ABBREVIATED PLAT AGENDA
ASSEMBLY CHAMBERS
350 EAST DAHLIA AVENUE, PALMER

STAFF REVIEW AND RECOMMENDATIONS
PUBLIC HEARING
NOVEMBER 8, 2023

ABBREVIATED PLAT: MANNEHULEN SUBDIVISION
LEGAL DESCRIPTION: SEC 17, T19N, R04W, SEWARD MERIDIAN AK
PETITIONERS: JON FUGLESTAD & THOMAS BOLING
SURVEYOR: KEYSTONE SURVEYING & MAPPING
ENGINEER: HOLLER ENGINEERING
ACRES: 5.2 ± PARCELS: 2
REVIEWED BY: MATTHEW GODDARD CASE #: 2025-030

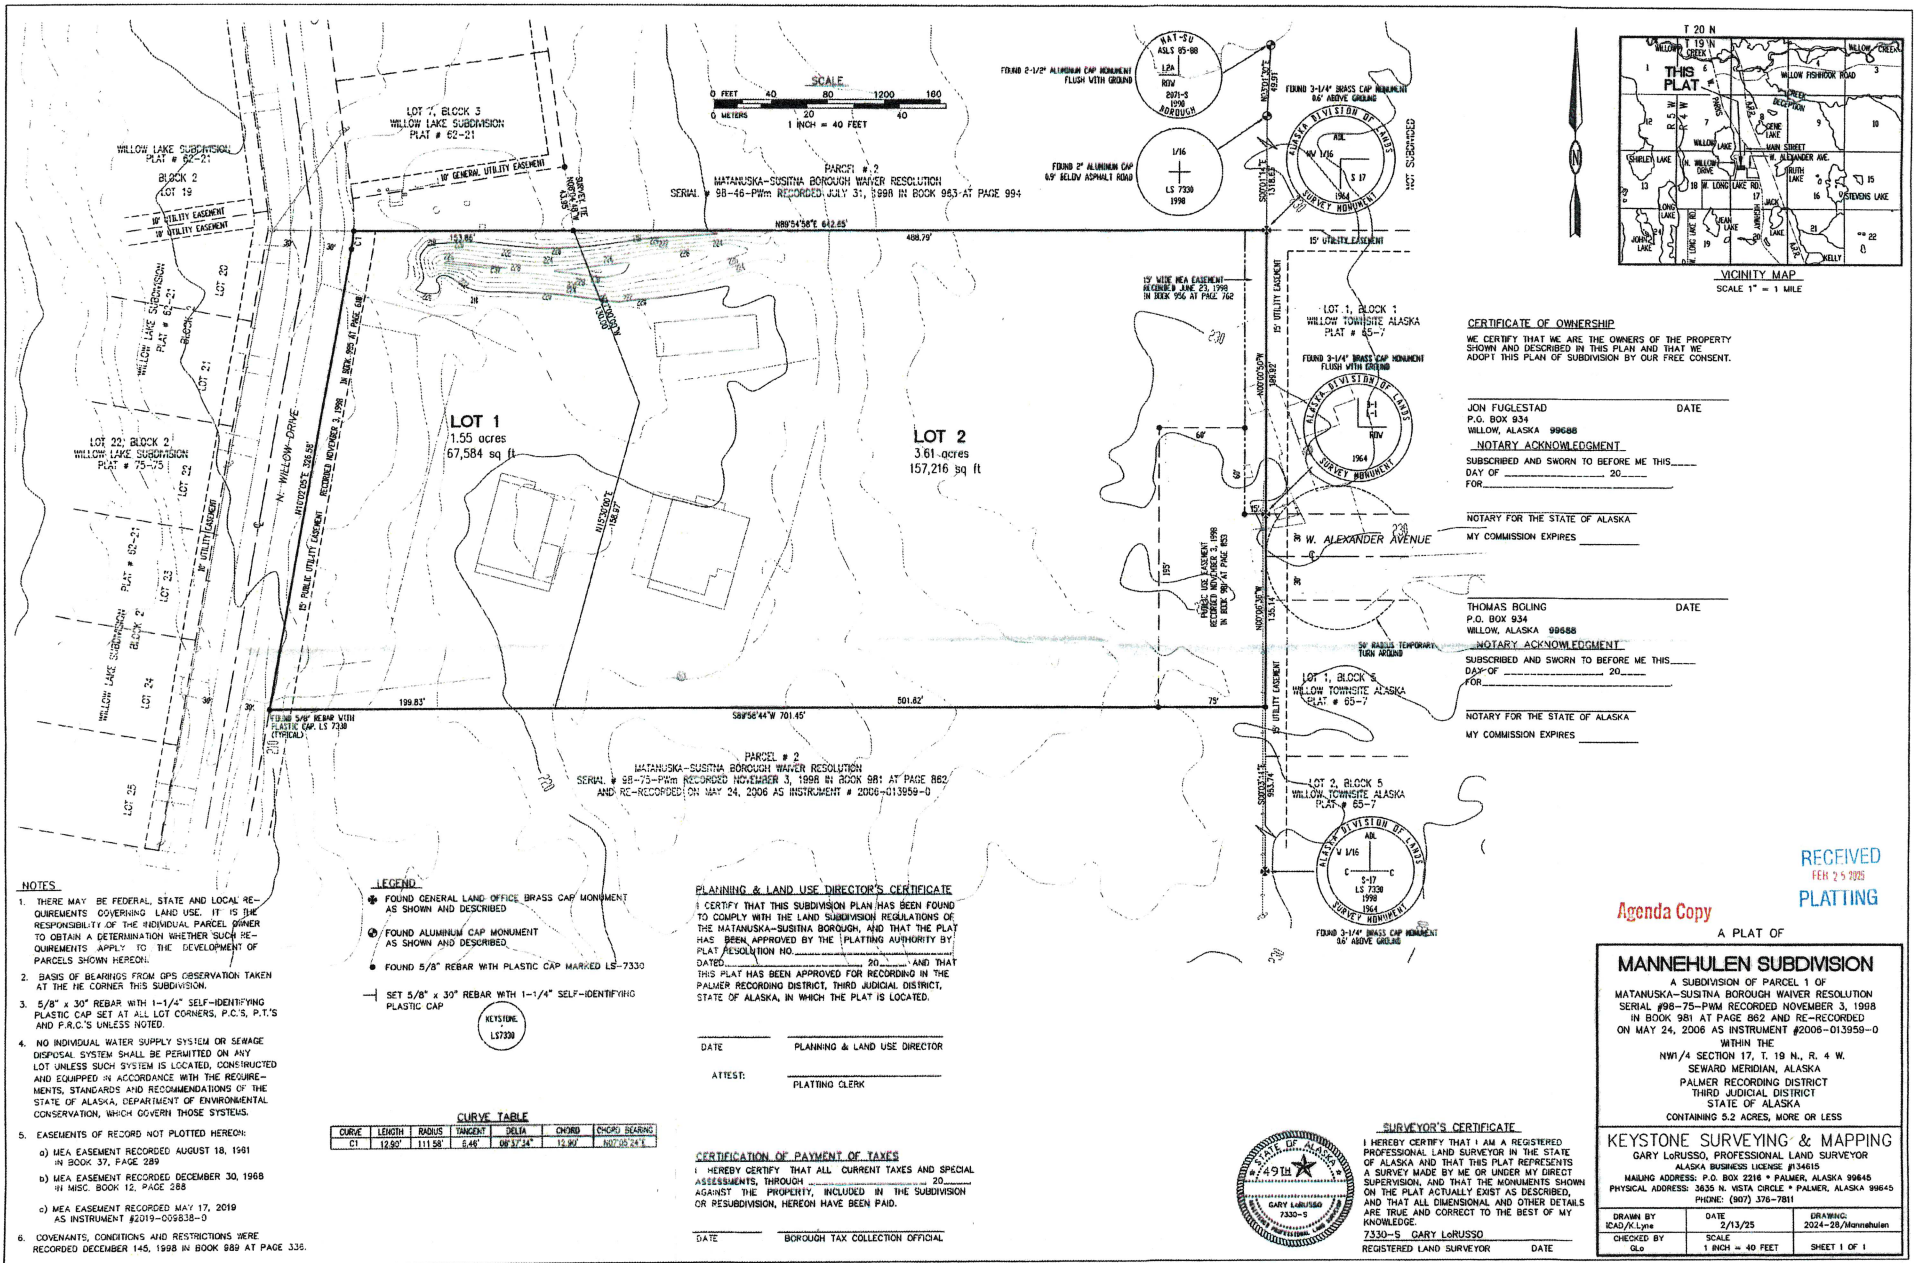
As-Built & Topographic Map were submitted and can be found at **Exhibit C**. Based on the submitted as-built, there are two sheds located on the eastern boundary of the property that are currently within a MEA easement and/or a public use easement located at the end of W. Alexander Avenue. These structures will need to be moved prior to recordation (**Recommendation #4**).

3. Pay postage and advertising fees.
4. Remove/relocate all structures currently in violation of MSB 17.55.010 Setbacks. Provide platting staff an updated as-built showing that no setback violations exist, nor will any be created by the proposed action.

Agenda Copy
A PLAT OF

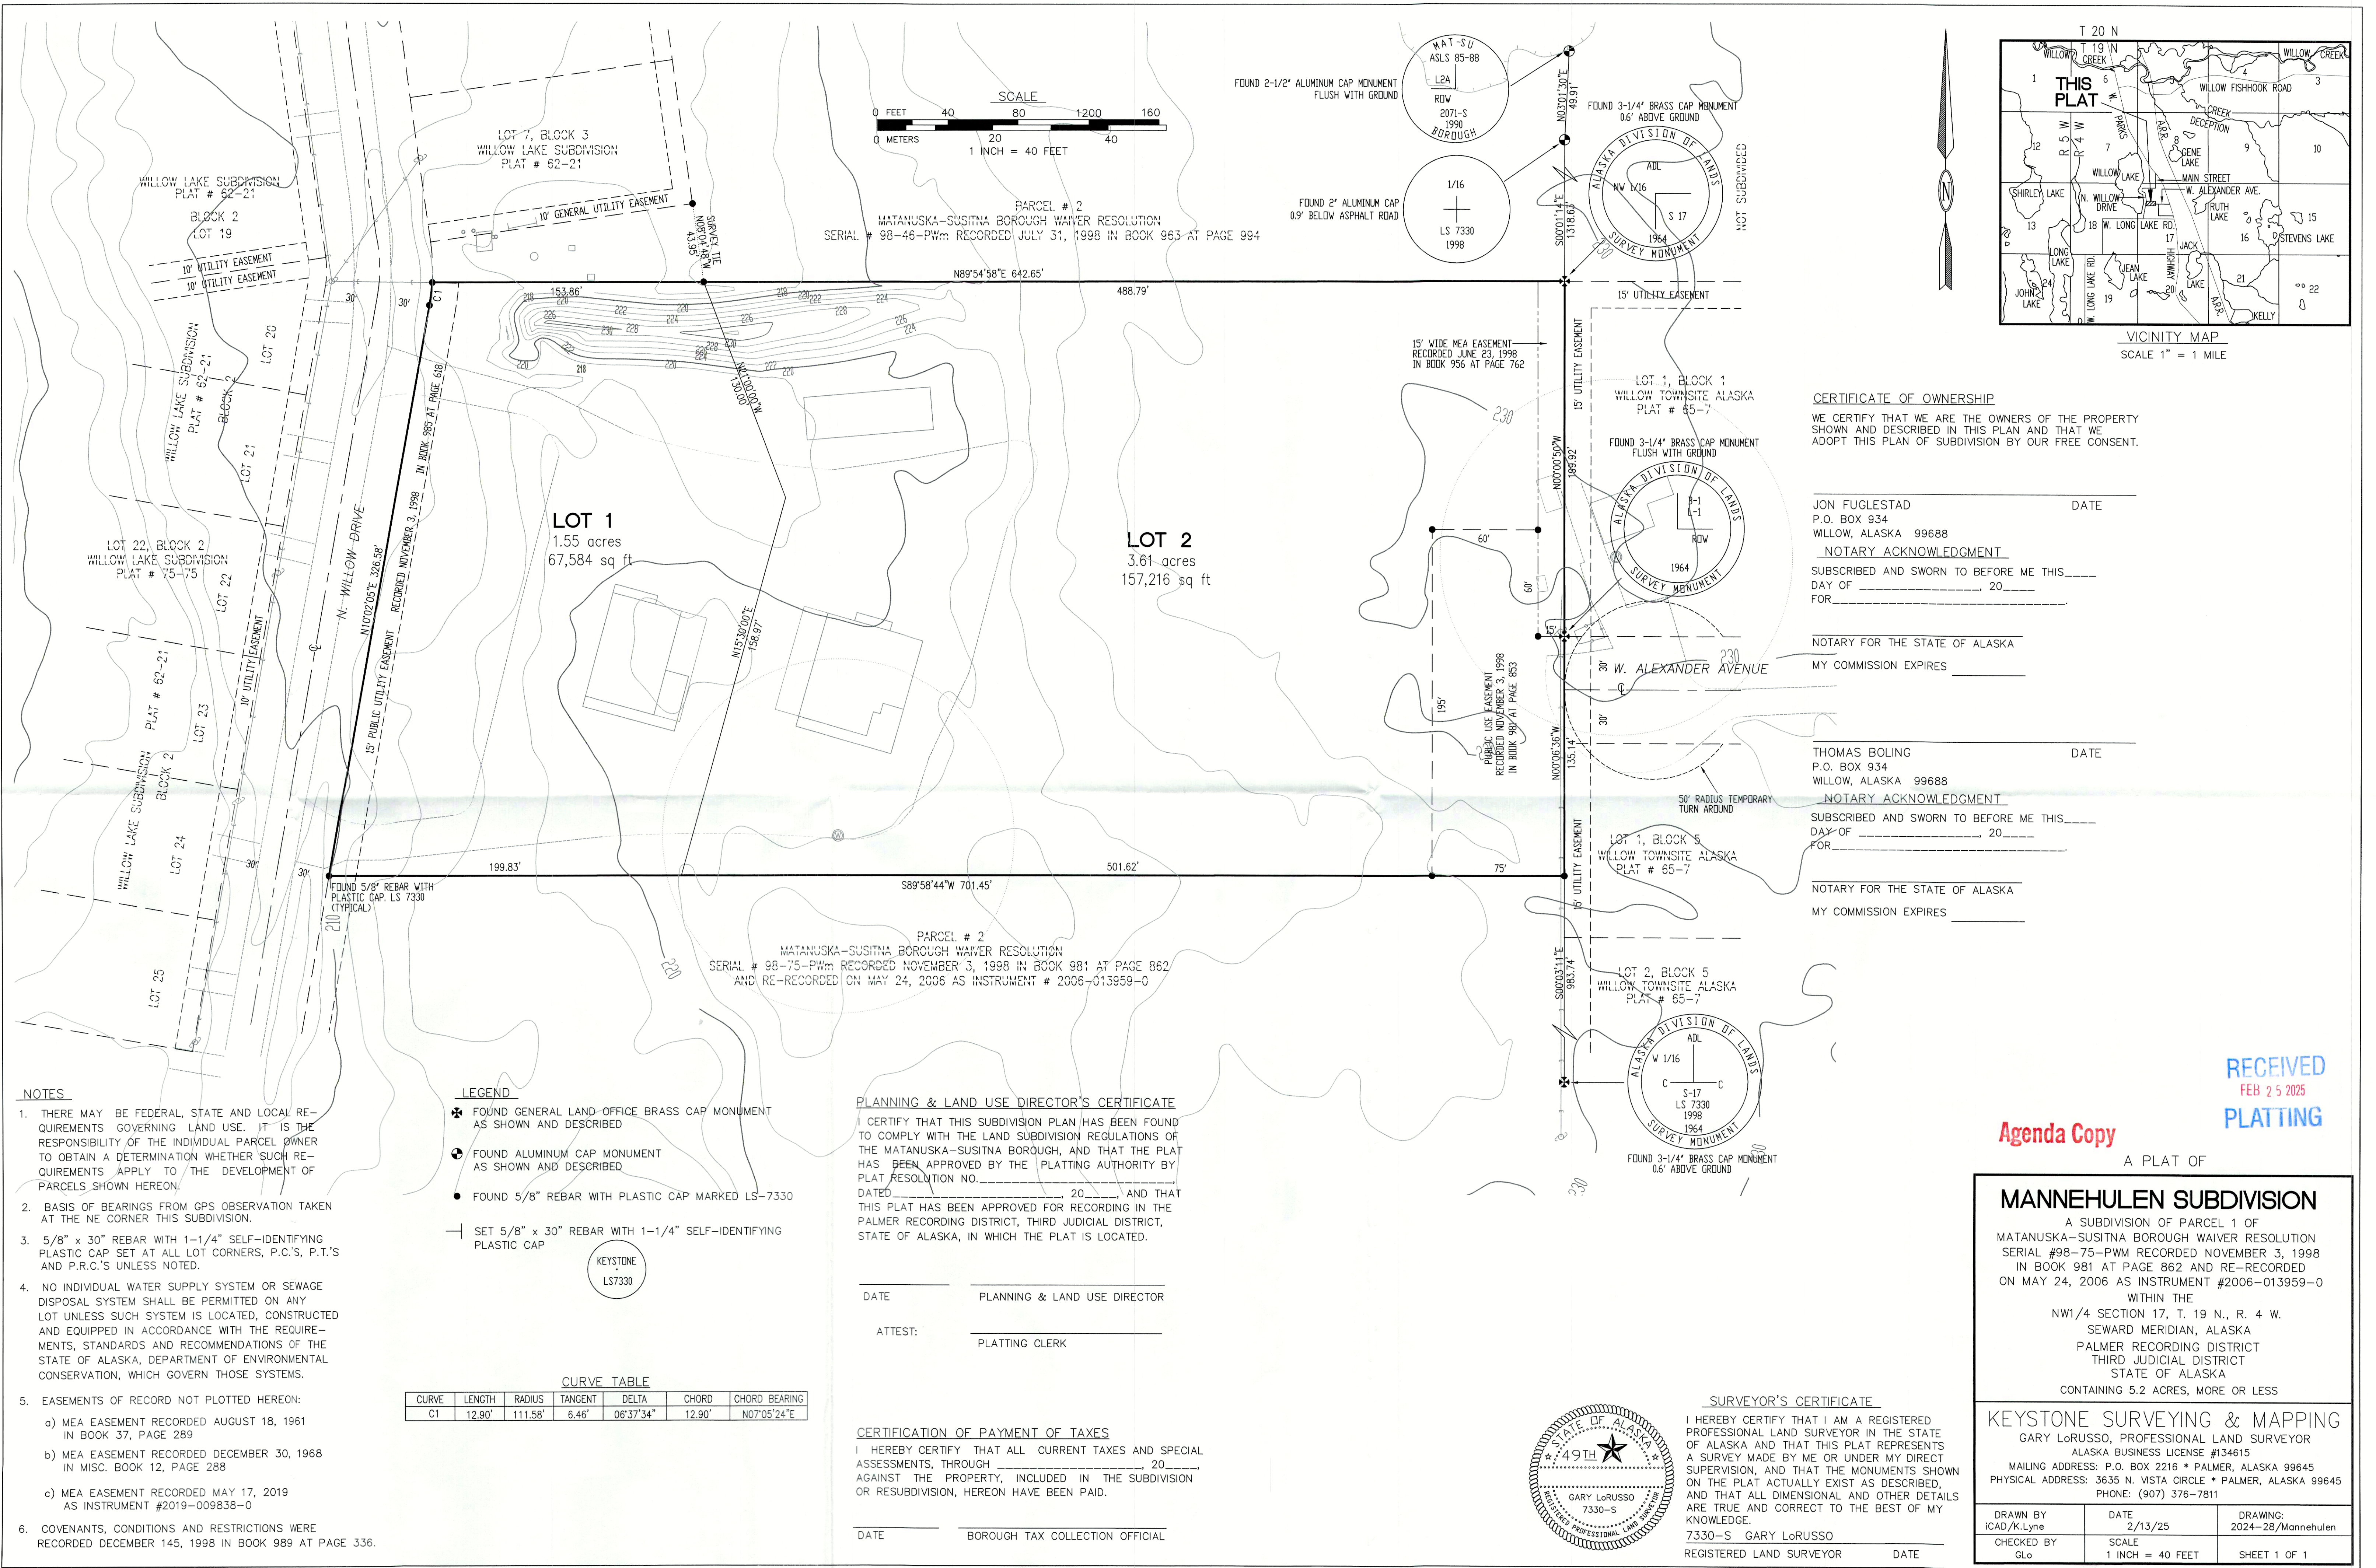
Willow Caswell FSA has one issue that needs addressed. On the As-Built it shows the new lots and the lot lines. Lot 1 will be addressed off N Willow DR. and lot 2 will now be addressed off the public use easement from W Alexander Ave. but the As-built does not show a driveway from the public use easement to the structure. With this addressing our dispatch location, address and mapping will direct us to W. Alexander Ave. Please confirm that a new driveway will be installed and it will be large enough to support the weight and width for Fire and EMS to navigate to the structure. The As-Built or the agenda plat does not call out for a common driveway and with addressing it could delay response having the common driveway especially if lot 2 is address from W. Alexander Ave where the public access is.

Thanks Matthew. They've applied for the north driveway, but still need to apply as shown. It also looks like the PUE to the east may be used as a driveway; if so, they'll need a permit.

Platting staff notes that addressing is handled after the platting process and will be addressed between the petitioner and the Borough Addressing Division.

5. Apply for driveway permits for all non-permitted accesses. Provide platting staff a copy of all submitted permit applications/driveway permits.
6. Show all easements of record on final plat.
